Health Consultation

Technical Review
Inhalation Pathway Interim Measure Approach
Groundwater to Indoor Air Pathway
Philip Services Corporation – Georgetown Site
Seattle, King County, Washington

August 9, 2005

**The Washington State Department of Health
Under a Cooperative Agreement with the
Agency for Toxic Substances and Disease Registry**

Figure 1: IPIM Decision Tree⁷
 Philip Services – Georgetown Site
 Seattle, Washington

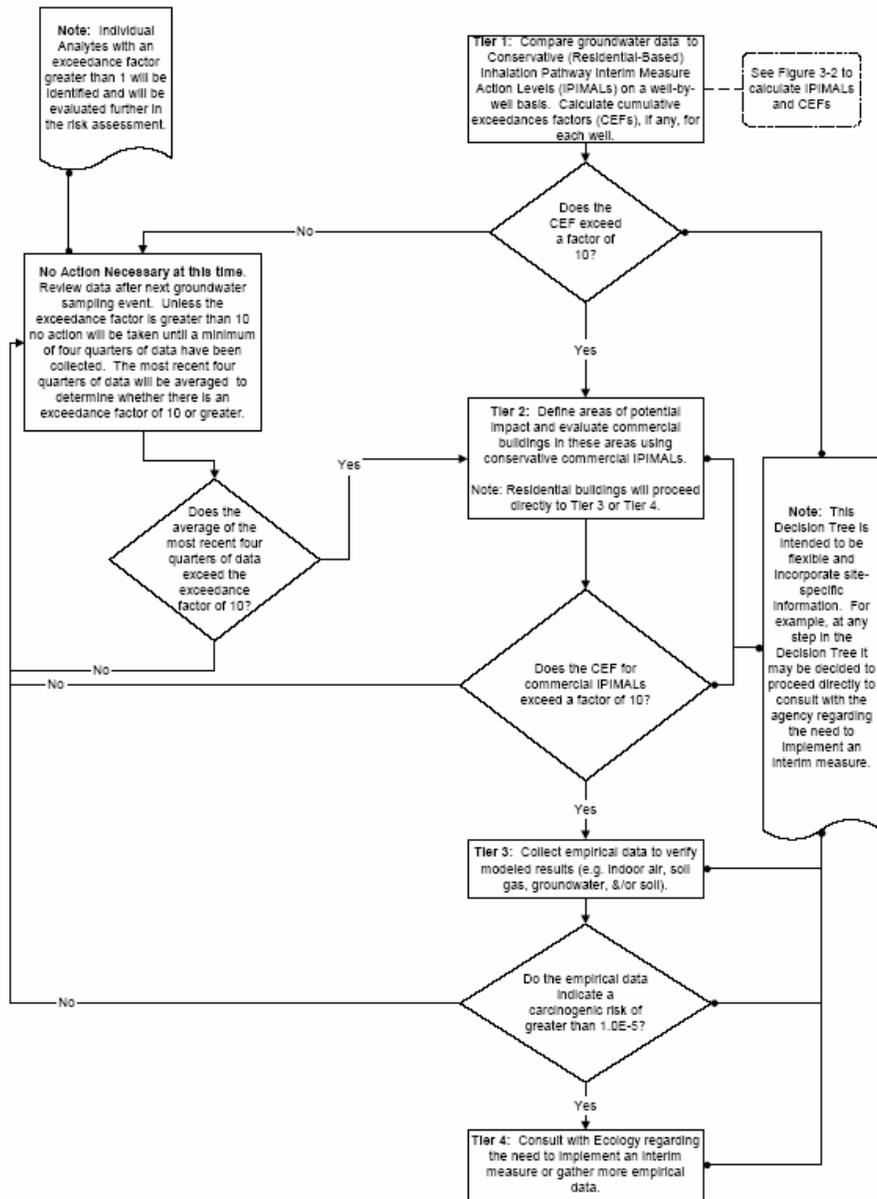
Groundwater results obtained from individual monitoring wells and direct push borings were divided by groundwater IPIMAL to obtain an exceedance factor (EF). Mainly groundwater monitoring wells screened across the water were used for this evaluation. In some cases, however, wells screened in the shallow aquifer but screened below the water table were used.

The EFs were then summed for each location to obtain cumulative cancer and non-cancer EFs (CCEFs and NCEFs, respectively). The cumulative EFs (CEFs) were then plotted and contoured to determine potential areas that could be affected by the groundwater. PSC selected residential buildings within the contours exceeding 10 CEFs for Tier 3 evaluation or to proceed directly to Tier 4, where interim actions (e.g. vapor vacuum systems) are designed and implemented. Commercial/industrial buildings within contours exceeding 10 CEFs or greater were considered for Tier 2 evaluation. A CCEF and NCEF of 10 indicate that exposure to indoor air concentrations near the sampling location could potentially result in a cumulative risk of $1E-05$ or a hazard index (HI) of 1. Locations where CEFs were less than 10 were sampled during subsequent quarterly groundwater monitoring events.⁷

- Ecology and PSC should address whether the number and distribution of wells or other groundwater sampling points (e.g. new direct push) are adequate for conducting the Tier 1 evaluation since this approach is being considered as part of the final actions at the site. If the monitoring network is inadequate, it should be expanded as appropriate.

- Some indoor air sampling should be conducted by PSC at buildings where CCEFs and NCEFs are less than 10 to confirm that PSC's approach is correctly identifying buildings where VOC contaminated groundwater poses an indoor air health threat. Ecology and PSC should consider a subset of vulnerable subset of such buildings, based perhaps on structural characteristics, for this confirmation sampling.

- Some wells screened below the water table were used for the Tier 1 evaluation where no water table wells existed. DOH recommends that Ecology and PSC consider adding water table wells or other types of water table sampling points (e.g. direct push) at these locations if these are appropriate monitoring points and it is likely that water table COPC concentrations exceed levels measured at the lower depths.

Commercial/industrial locations that exceeded a groundwater CEF of 10 were evaluated again in Tier 2. However, the steps appear to be the same as Tier 1 except that PSC notes that locations exceeding a CEF exceeding 10 will be further evaluated under Tier 3 of the IPIM decision tree.⁷

The purpose of Tier 3 is to collect property specific data (e.g. indoor air, soil gas, groundwater, and/or soil) at locations where groundwater CEFs exceeded 10 in Tier 1 or 2 to determine if interim measures are necessary. As done in the GIVF step above, indoor air sample results are adjusted for background contributions. These adjusted results are then divided by residential and commercial/industrial indoor air IPIMALs to obtain EFs and CEFs as described in Tier 1, above. Only COPCs detected in groundwater and soil gas are included in the Tier 3 evaluation because it is assumed that this represents a completed pathway.⁷ This appears to be a reasonable approach if groundwater and soil gas sampling are conducted appropriately. However, it was determined in early 2005 that there are some problems with PSC's soil gas sampling method, resulting in an underestimation of the contaminant levels in soil gas.

PSC's Tier 1 approach seems reasonable if the following recommendations are addressed by Ecology and PSC.

Recommendation: Ecology and PSC should resolve the soil gas sampling problems for future evaluations. In addition, Ecology and PSC should ensure that sampling intervals for indoor air and ambient air are consistent with planned sampling intervals (e.g. 24 hour samples for residential structures).
